DRAFT TECHNICAL MEMORANDUM

DATE: August 18, 2023

RE: **Comments and Recommendations – Gordon Lakes: Camlaren Tailings and Soil Containment Area (TSCA) Geotechnical Investigation**

Figure 2 Camlaren Mine TSF

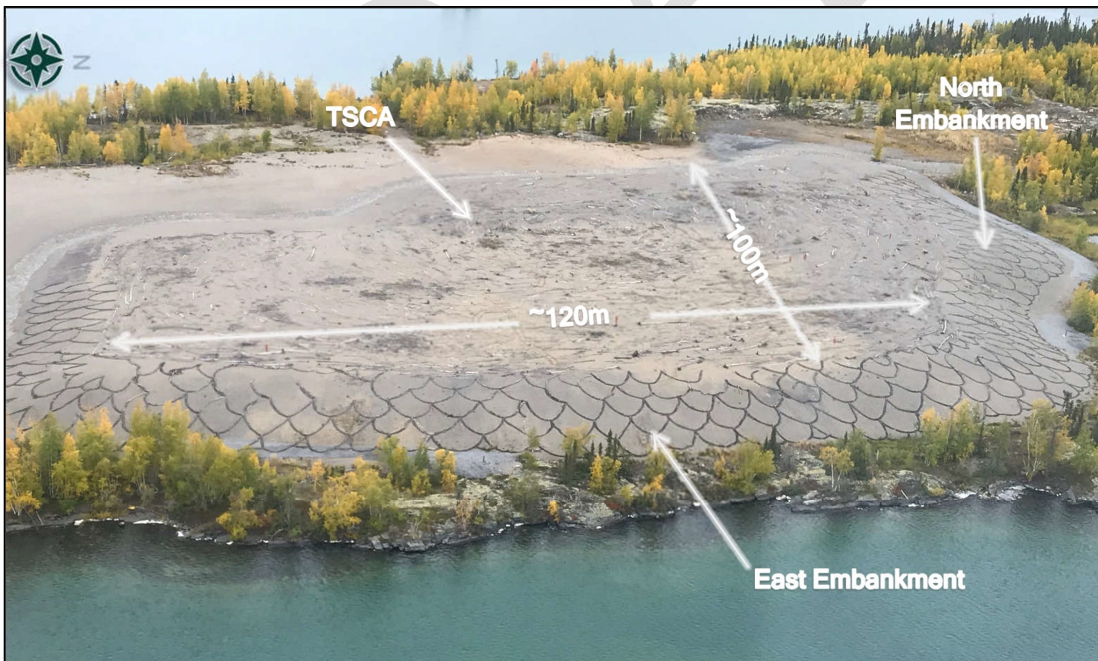
The TSCA was closed and covered in 2018. The outer dam slopes were stabilized, fill was placed to create a domed surface over the entire facility with slopes of approximately 4%. To limit water infiltration, a cover system was constructed consisting of a Bituminous Geomembrane (BGM) overlain with a 0.5 m thick sand layer. Erosion protection consisted of providing vegetation (willow branches) along the top of the TSCA and a coarse sand with rockfill and coco mats on the dam slopes (Figure 2).

The Panel considers features such as willow branches and coco mats are only suitable in the short term and should not be relied upon for the long-term, and questions whether sufficient vegetation can be established to provide for erosion protection in the long-term.

- *Consult with an experienced biologist / revegetation expert with experience in northern soils and vegetation to assist in establishing a plan to upgrade the cover system so it is more erosion resistant and conducive to the establishment of a vegetated cover.*

Figure 3 Plan View Showing Cross Section Boring Locations and Possible Extent of Liquefiable Tailings Based on Robertson 2021

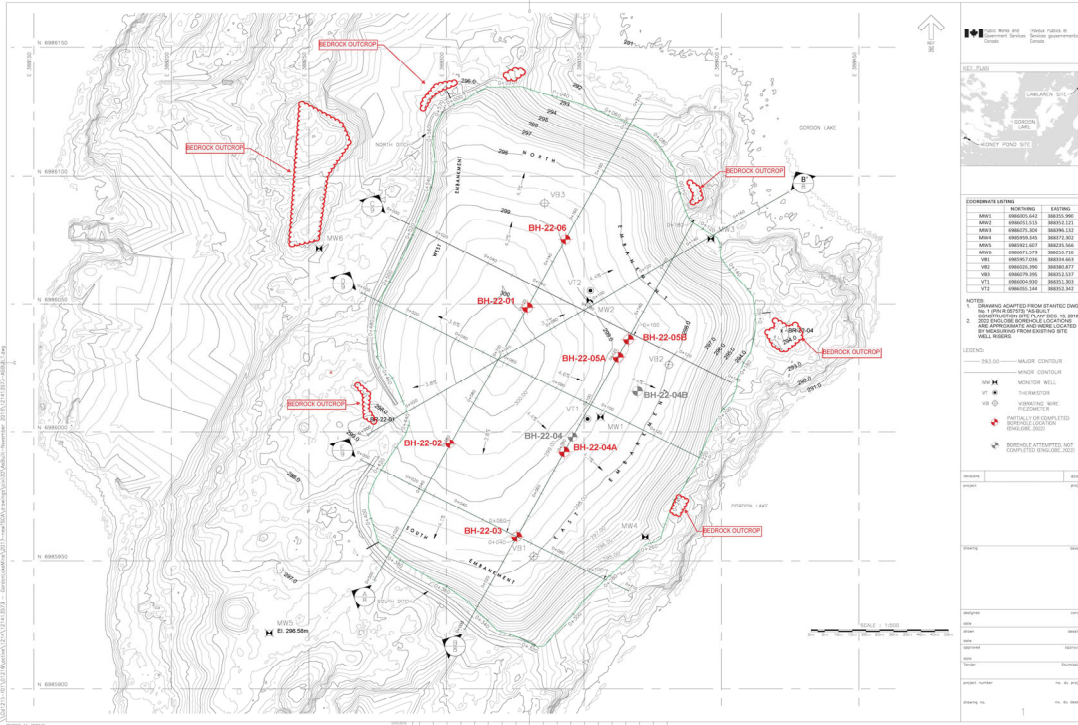
The Panel notes there appear to be inconsistencies between the boring shown in plan view (Figure 3) and the cross-section B (not shown) of the report and some of the plot locations on Figure 7 appear to be incorrect.

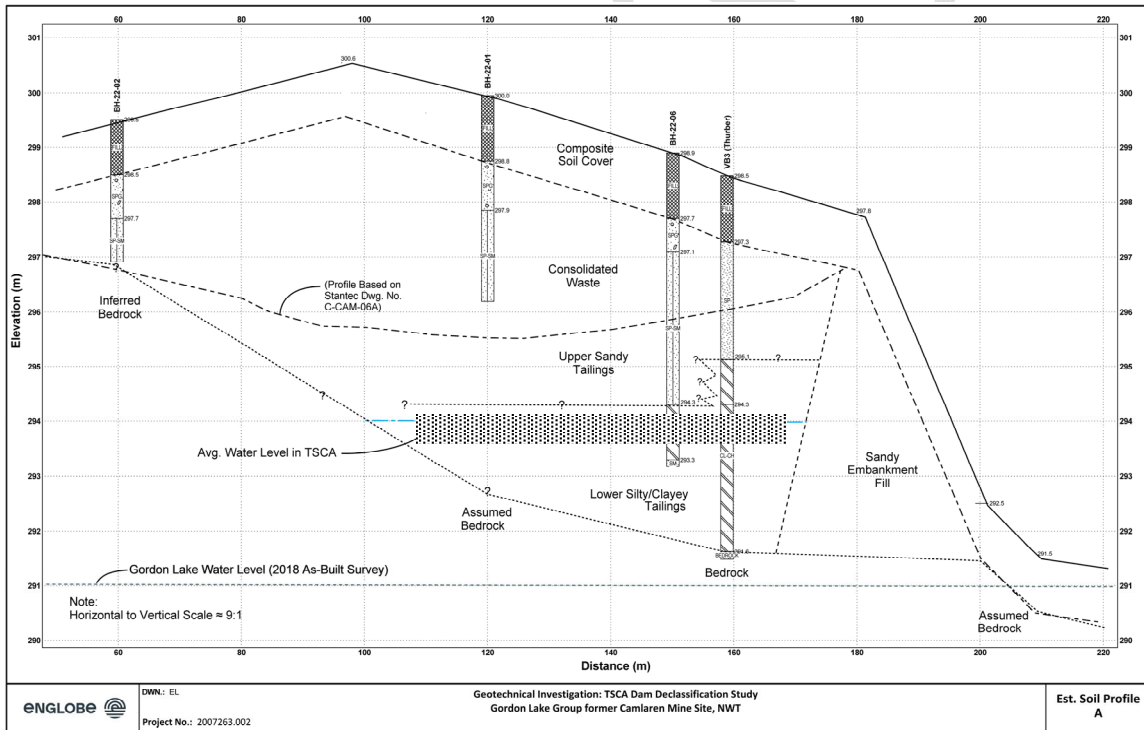
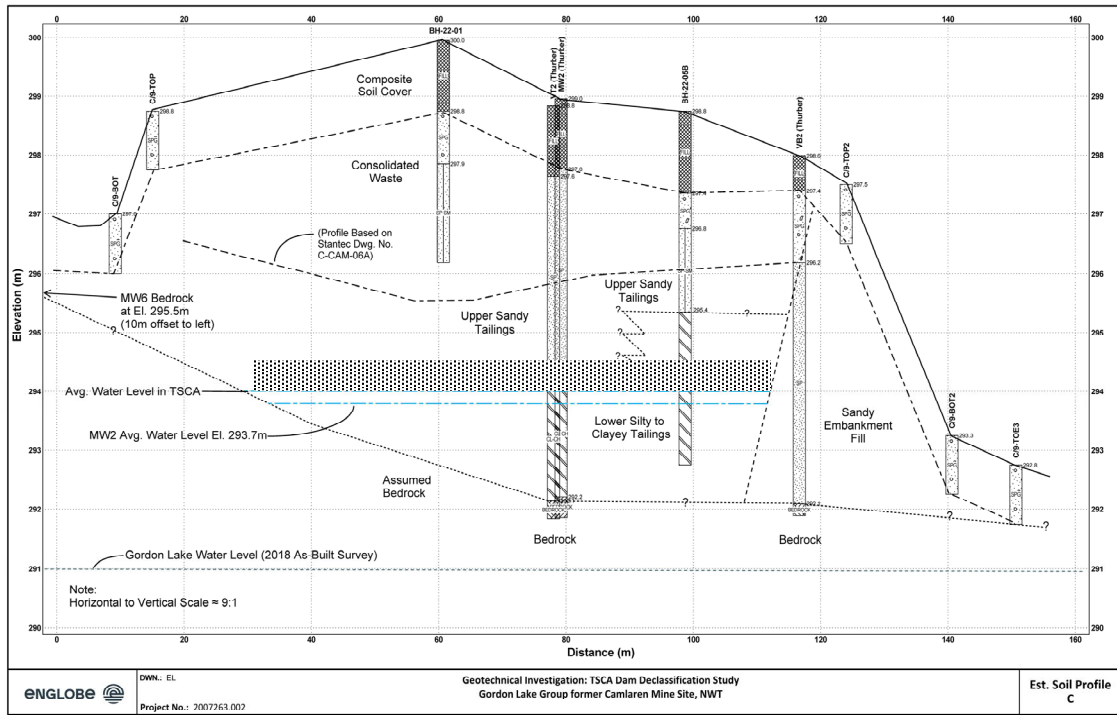
Based on the more recent 2021 chart, the layers that are potentially liquefiable include BH-22-06 (4.9-5.5m) and BH-22-05B (4.- 4.8 m), which would be considered contractive (see Figures 4, 5 and 8).

The Panel judges the total volume of tailings may be in the 20,000 to 40,000 m³ range based on the sections provided in the report. Furthermore, assuming worst case, the zones identified as potentially liquefiable represent continuous zones (Figures 4 and 5); the Panel’s rough estimates of the volume of potentially flowable tailings appear to be approximately 10% of this volume. The relevance of these small amounts of total and potentially liquefiable tailings is discussed further in Section 4. Overall, the capacity of the TSCA is cited as 80,000 m³ (Englobe 2022a).

- *Elaborate on the characterization of the TSCA considering the following:*
 - *Update the liquefaction analyses considering the most recent developments in this field.*
 - *Refine and use the stratigraphic modeling of the TSCA to estimate the total and potentially liquifiable tailings volumes. Consider these in context with the CDA definition of a dam as discussed in Section 4.1.*
 - *Obtain geochemical data on the tailings, include acid-base accounting testing and both total and leachable mineral and metal content to address the chemical stability finding requirements.*
 - *Assess the filter compatibility between the tailings and the dam construction materials.*

Figure 7 CPT Results Plotted by Englobe on Chart Developed by Robertson (1990)

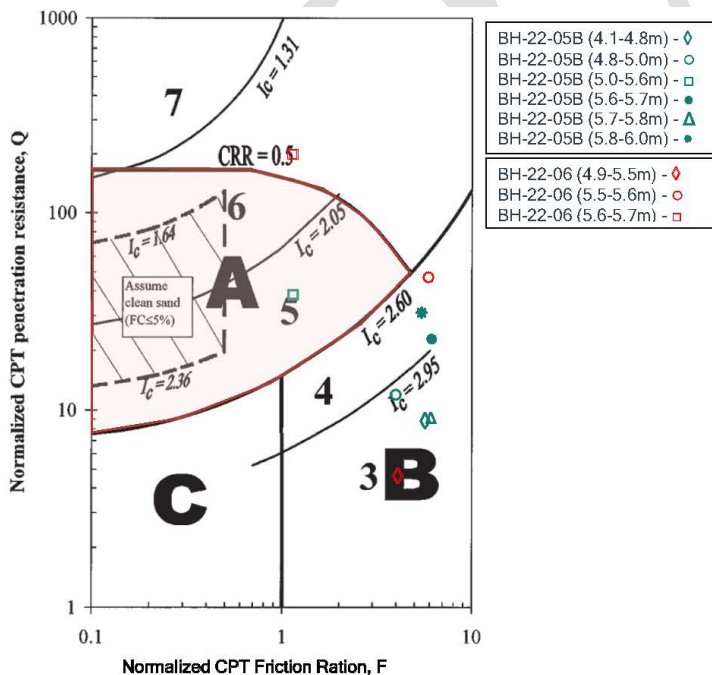
Englobe (2022) using a chart generated by PK Robertson (1990), a recognized international expert in assessing liquefaction potential in granular materials, to assess the liquefaction potential of the tailings

in the TSCA. The results indicate only one 0.6 m thick layer of tailings, classified as “sand to silty sand”, could potentially be considered to be liquefiable.

The Panel notes that since the Robertson publication in 1990 significant advances have been made in establishing methods to assess liquefaction potential and there have been several major Tailings Storage Facility (TSF) failures that have provided valuable data against which the relationships have been calibrated. The current version of Figure 7 has evolved into that provided in Figure 8 with a more detailed interpretation of the condition of the assessed tailings. The indicated behavioral zones (Figure 8) include:
